Infonote

AO-IN-2022-035-I

Update of pulse derating for FIREFLEY E1608

01.12.2022

Permissible Pulse Handling Capability

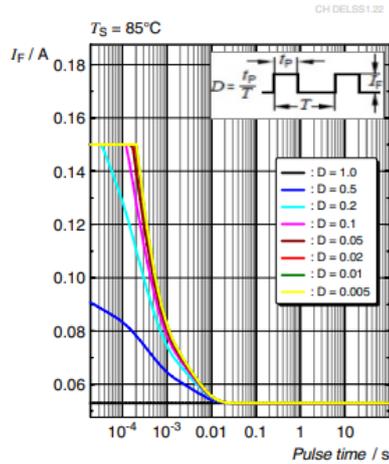
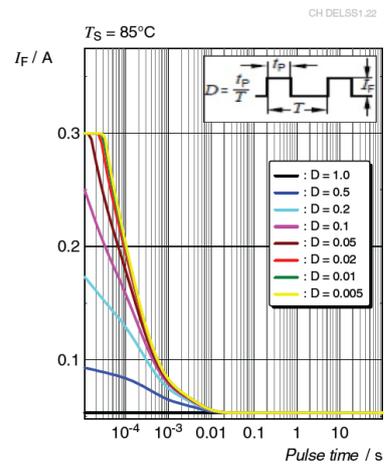
Objective:	Update of pulse derating for FIREFLY E1608
Affected products:	CH DELSS1.22
Reason for change:	Based on marketing requirement, the pulse driving current was increased from 150mA to 300mA. The chip is released until 300mA and the product was upgraded accordingly.

Description of change:	<u>Current status</u>	<u>New status</u>
	<p>Permissible Pulse Handling Capability $I_F = f(t_p)$; D: Duty cycle</p>	<p>Permissible Pulse Handling Capability $I_F = f(t_p)$; D: Duty cycle</p>

Assessment: There is no change of the affected product. The characteristic graphs for Forward current vs. Voltage and Relative Radiant Intensity are updated until 300mA.
